**STRATEGIC PLANNING COMMITTEE – 19<sup>th</sup> July 2023**  
**ADDENDUM TO OFFICERS REPORT**

**Item No:** 6

**Reference:** 23/1082/FUL

**Address:** Barnet Elizabethans Rugby Football Club; Byng Road; Barnet; EN5 4NP

Light spill to northern tree line from floodlighting to pitch 1

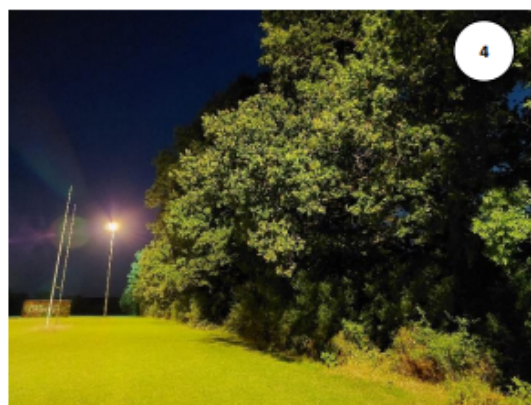
There remains a concern that relate to light spill penetrating the interior of the adjacent woodland and hedgerow at a low level (see below), however this could be effectively mitigated through the provision of a hedgerow around the perimeter of the field. The provision of a boundary hedge must be a condition of any approval granted to maximise the amount of shading that can be created for these sensitive ecological areas.

To ensure all these mitigations have been effective the LPA would seek to secure appropriate post development bat activity monitoring to determine the effect of the final external lighting post development to be compared to the baseline the findings of which will inform any modification to the lighting mitigation measures as appropriate.

Existing lux level on site during night-time survey carried out by CPW at 22:30 on 12th July 2023.

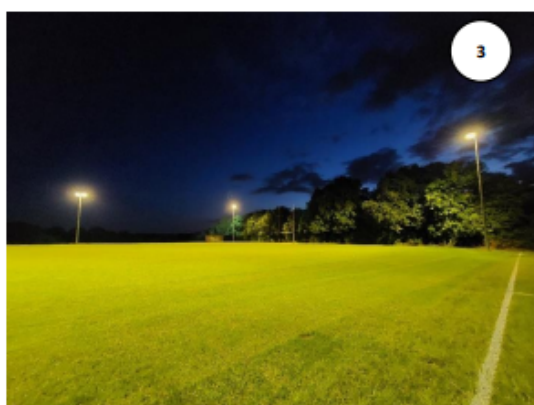
The submitted documents demonstrate a significant reduction in light spill along the boundaries of the site (see submitted table below) vegetation to a minimum 8.4 lux (-45.8 Lux, -78%) and maximum of 16.4 (-73.6 lux). These reductions mean that the applicant has demonstrated that the proposed lighting scheme is unlikely to have a detrimental impact on the local bat population. In addition, the applicant has also provided assurance that all proposed LED lighting of 4000K will be substitute for 2700K which provides a warm, less intrusive lighting for bats.
